Élan-Santa Monica Place

Dwg. Name:
STORM DRAIN DETAILS

Dwg. Name:
**GRADING AND
DRAINAGE PLAN**

CONCEPTUAL GRADING & DRAINAGE PLAN

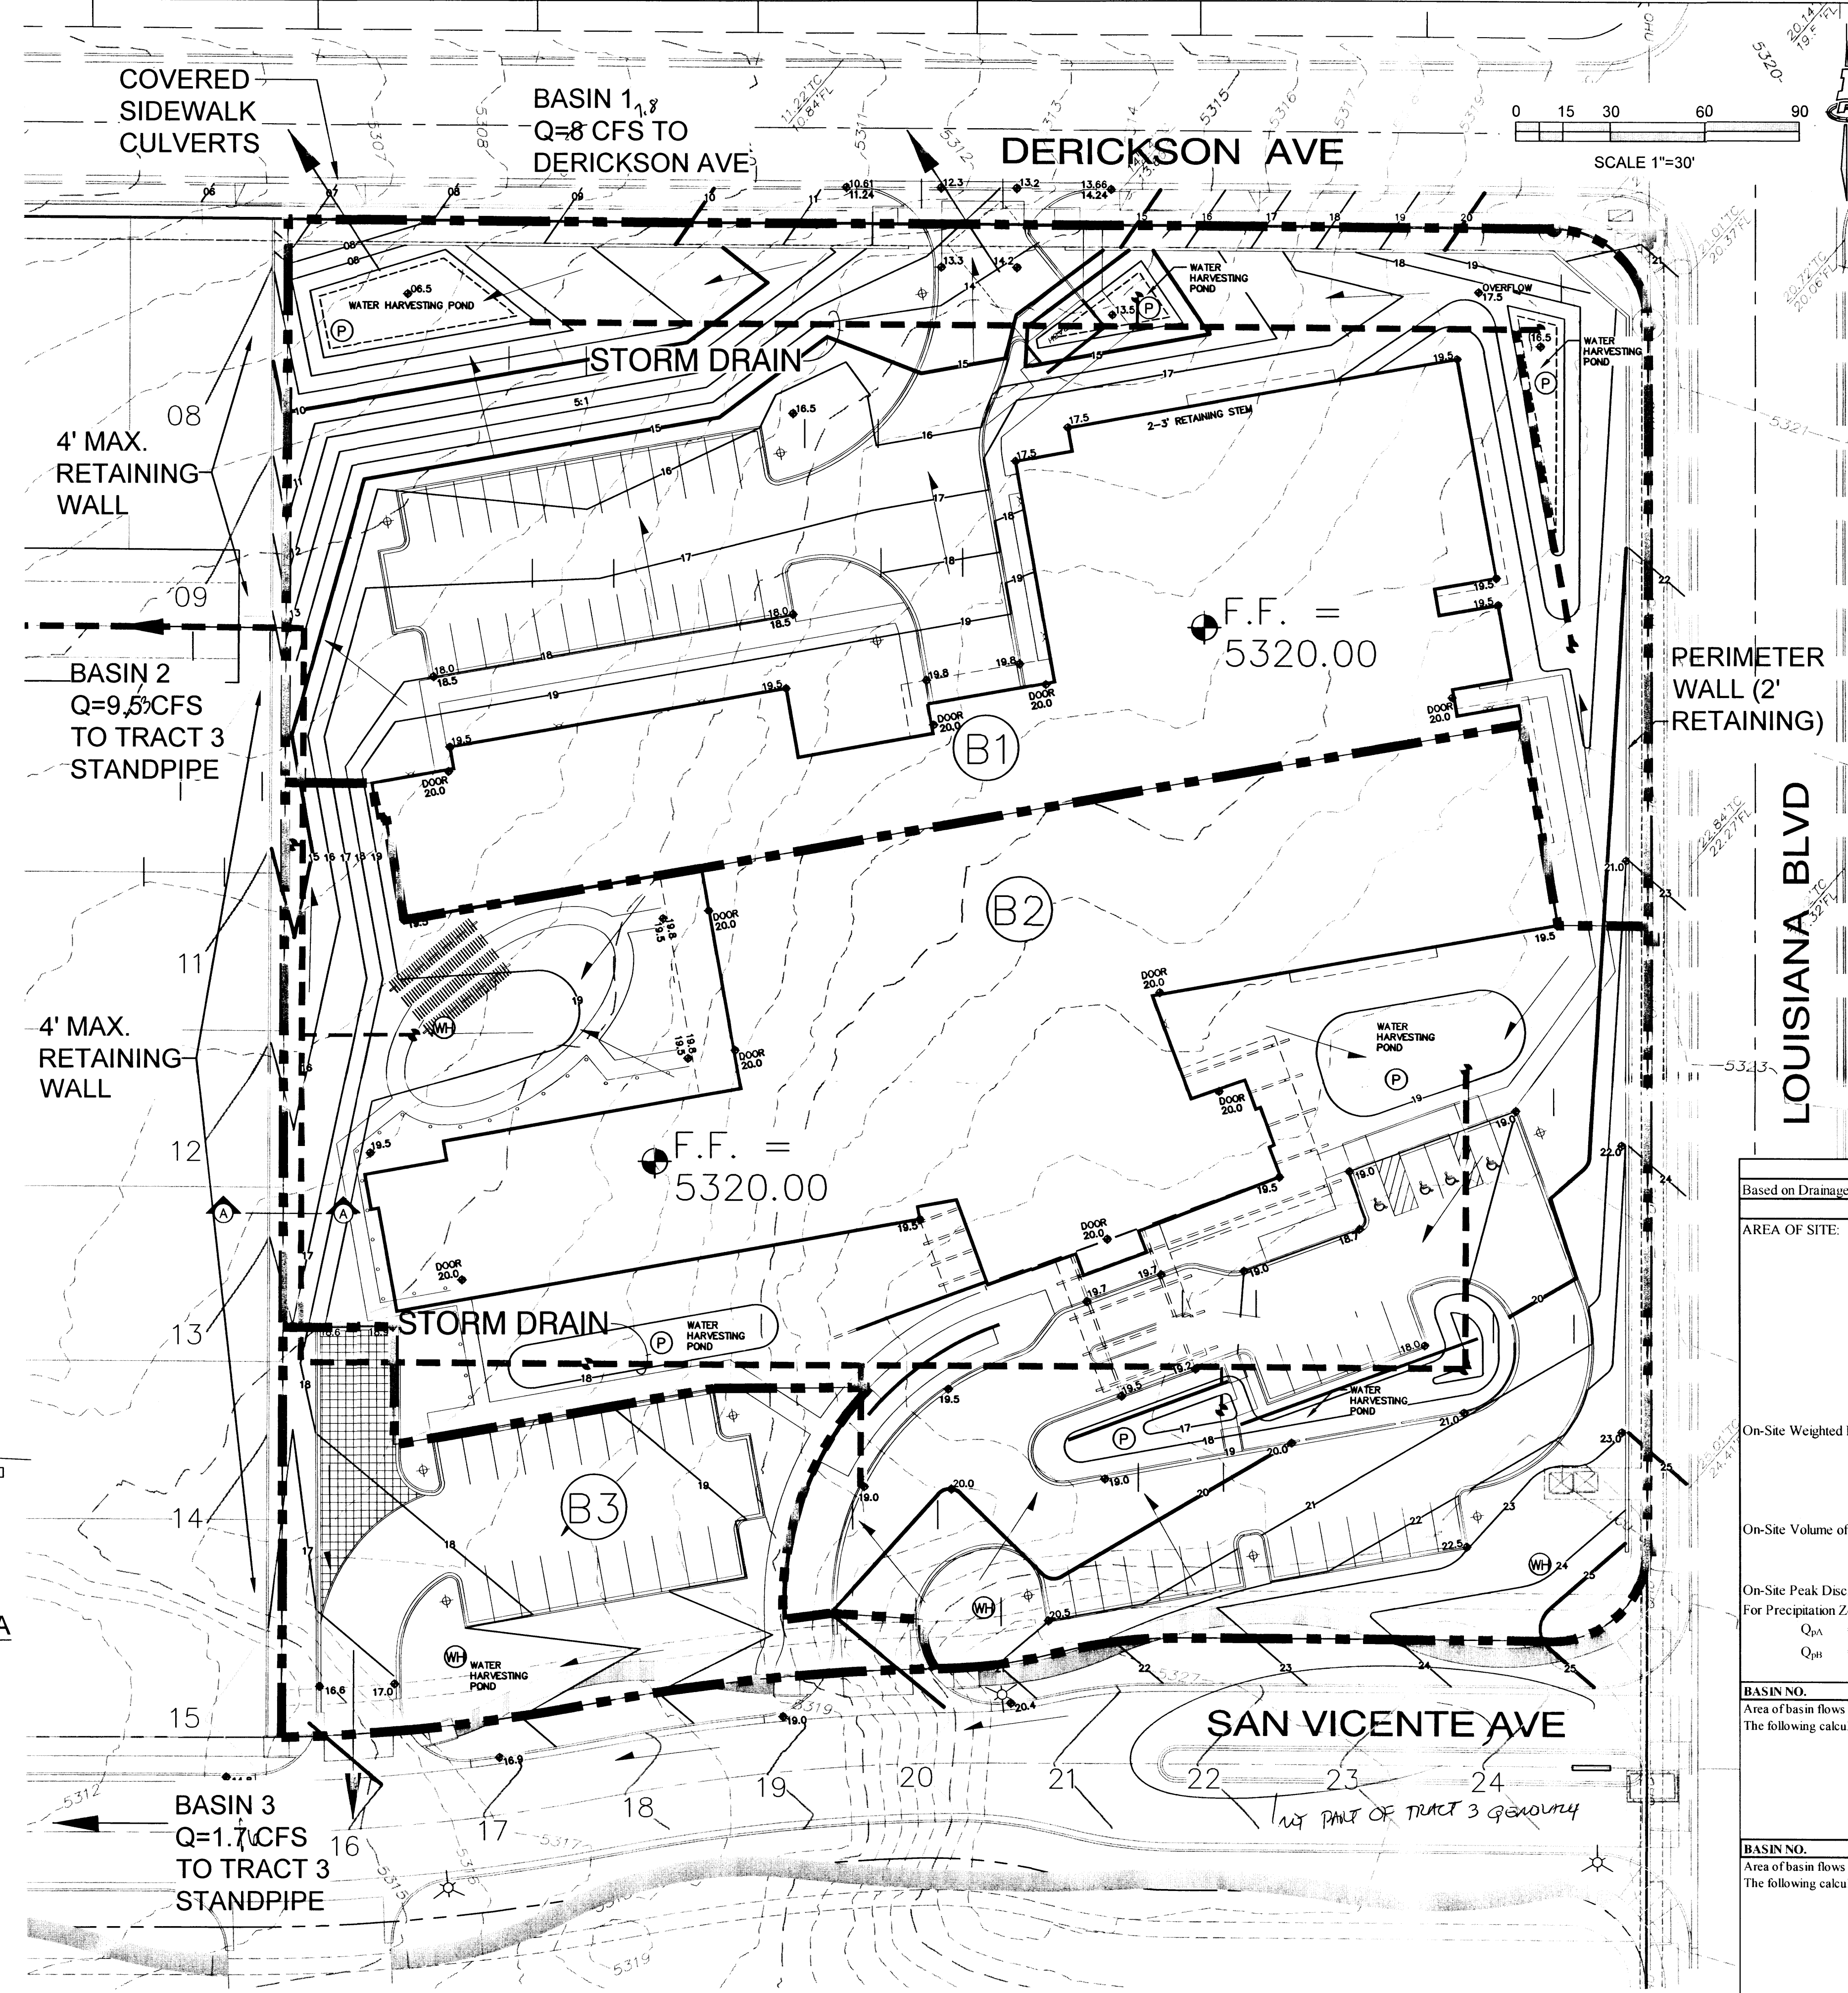
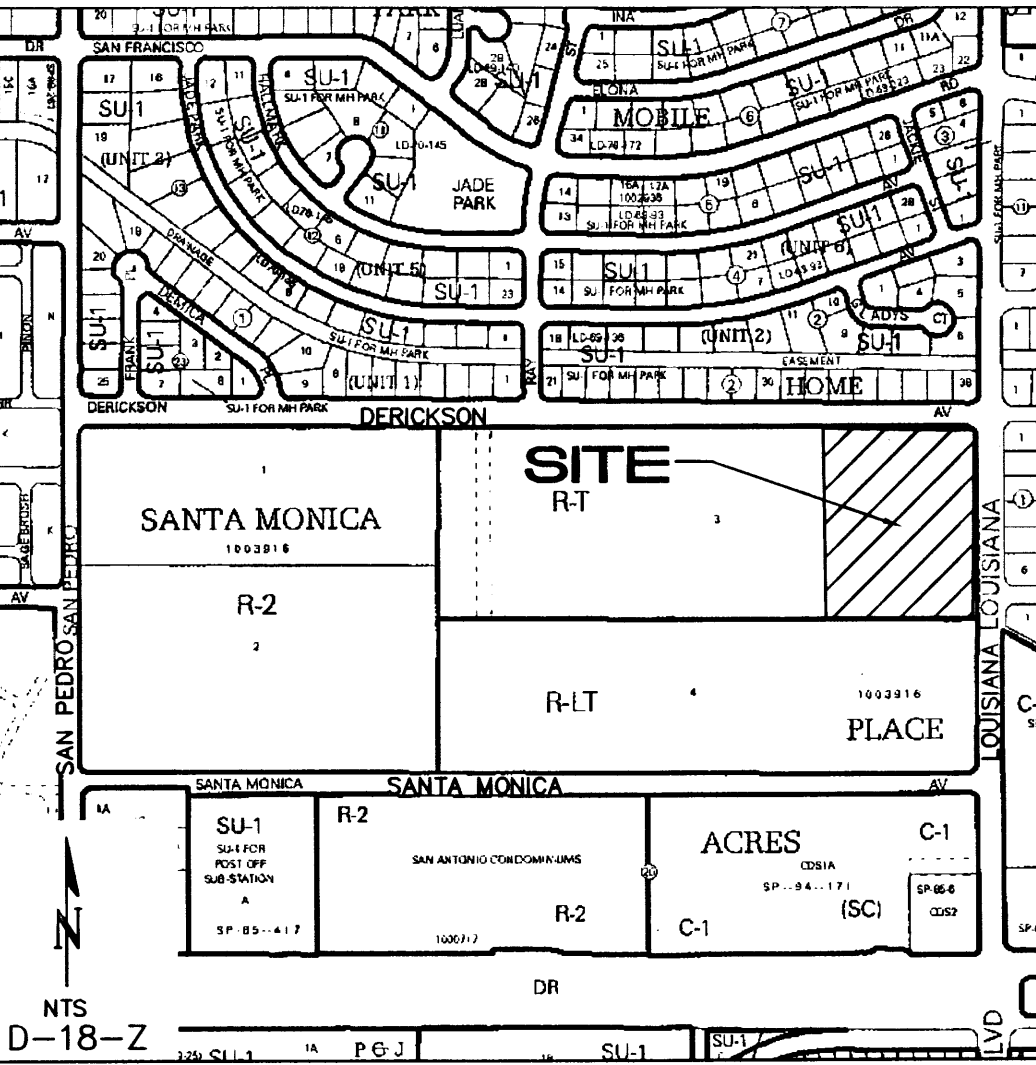
THESE BASIN CALCULATIONS DO NOT ACCOUNT FOR ANY WATER HARVESTING OR DETENTION BASINS WHICH MAY REDUCE THE TOTAL DISCHARGE RATES. *show first flush catchment*

18" DEEP DETENTION PONDS WITHIN EACH OF THE BASIN AREAS WILL BE UTILIZED TO DETAIN DISCHARGE, UTILIZE FOR LANDSCAPING / INFILTRATION AND RELEASE EXCESS. *show catch*
